S.G. Kimball, Inc. Site P
Windsor Hwy. (Shaw)

SUBJECT: S.G. KIMBALL SITE PLAN
NEW WINDSOR PLANNING BOARD NO. 94-11

TOWN OF NEW WINDSOR
PLANNING BOARD
REVIEW COMMENTS

PROJECT NAME: S.G. KIMBALL (GALLAGHER) SITE PLAN
PROJECT LOCATION: NYS ROUTE 32
SECTION 9-BLOCK 1-LOT 23.1
PROJECT NUMBER: 94-11
DATE: 25 MAY 1994
DESCRIPTION: THE APPLICATION INVOLVES THE DEVELOPMENT OF A NEW FACILITY ON THE EXISTING GALLAGHER TRUCKING PROPERTY ON THE WEST SIDE OF WINDSOR HIGHWAY (NYS ROUTE 32). THE PLAN WAS PREVIOUSLY REVIEWED AT THE 27 APRIL 1994 PLANNING BOARD MEETING.

FORMER PARCEL / FORMER EASEMENT PLAN
SCALE: 1"=100'

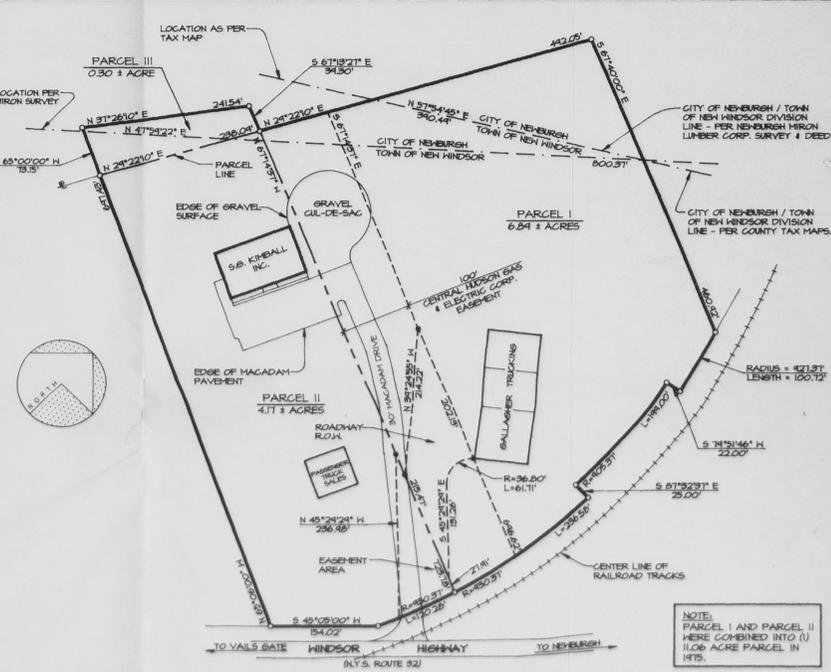
MR. SHAW: There was one originally, if you look into, I think it's on the second drawing in the bottom right-hand corner, you'll see that at one point in time, the site consisted of three different parcels. Not tax maps, just parcels referred to in the deed. I believe Mark is satisfied in that there has been a deed filed previously before this application which incorporated all of the parcels. That is why we're referring to that sketch as the former parcel.

1. One item of concern from the previous meeting was the potential existence of three (3) separate parcels for the overall property. Based on my review of the deed information submitted and based on a discussion I had with the project land surveyor, it is my understanding that the property, as it currently exists, is now two (2) parcels. Parcel One and Two (the great majority of the property) were combined and the small parcel (.3 acres) remains as a separate deed parcel. This is clarified on Sheet 2 of the drawings.

3. The parcel/easement plan on Sheet 2 indicates the existence of three (3) parcels and a roadway right-of-way within the property. The parcel lines and right-of-way lines are not consistent with the development. As such, I suggest that the Board recommend to the Applicant that they adjust these parcel lines and right-of-way line concurrent with this application, or at some time in the future, to correct this situation.

LIGHTING PLAN
SCALE: 1"=40'

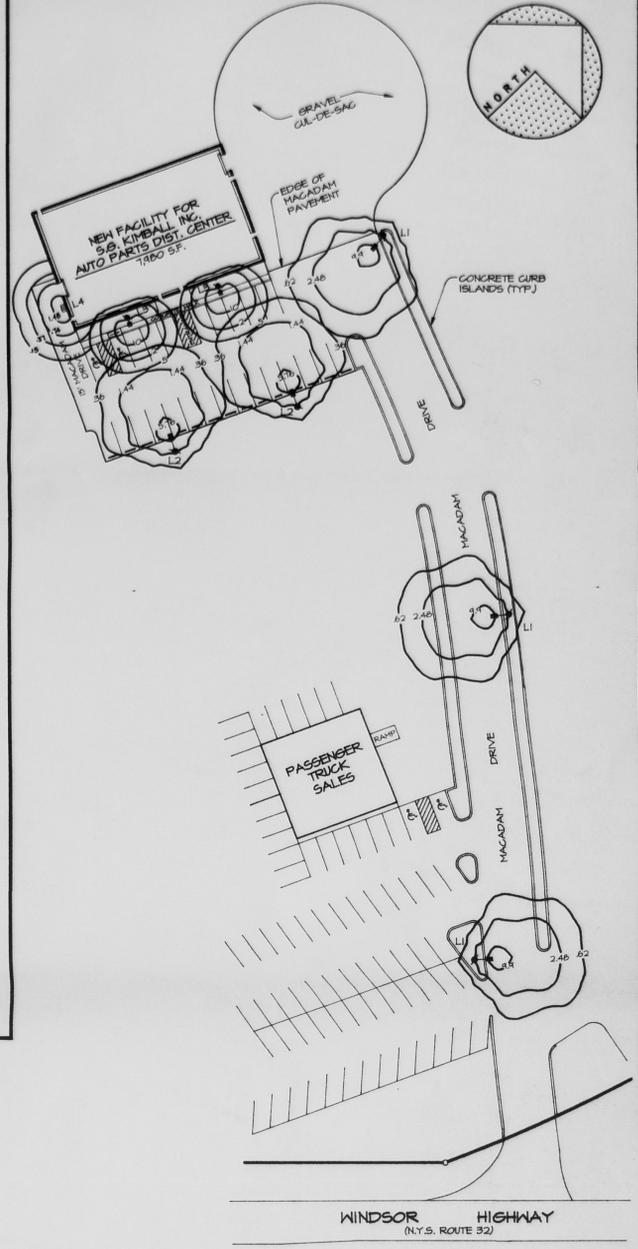
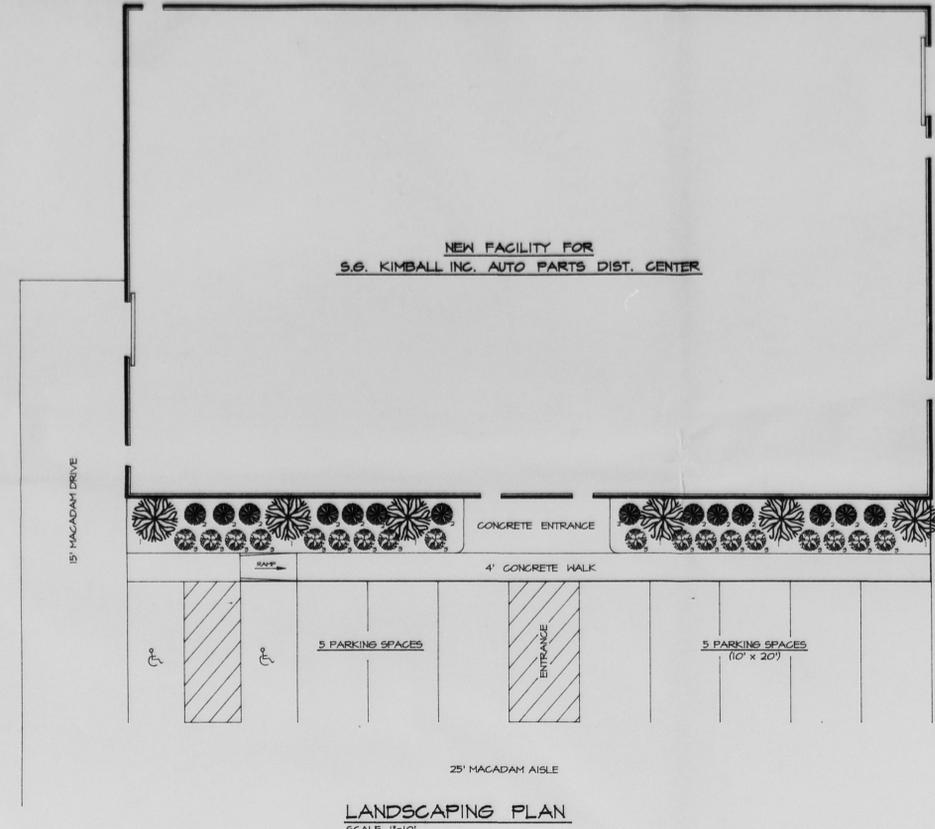
2. Pursuant to my discussions with the Applicant's engineer, the lighting plan provided for the project has been expanded and detailed to indicate the levels of the proposed lighting. I believe the proposed lighting configuration is acceptable for the proposed use.

4. The plans on Sheet 3 indicate that same are intended as landscaping and lighting plans; lighting information is only shown on the left plan. Insufficient information is provided to determine whether the lighting is adequate. The Board should determine if additional information is necessary.

MR. EDSALL: Yes.
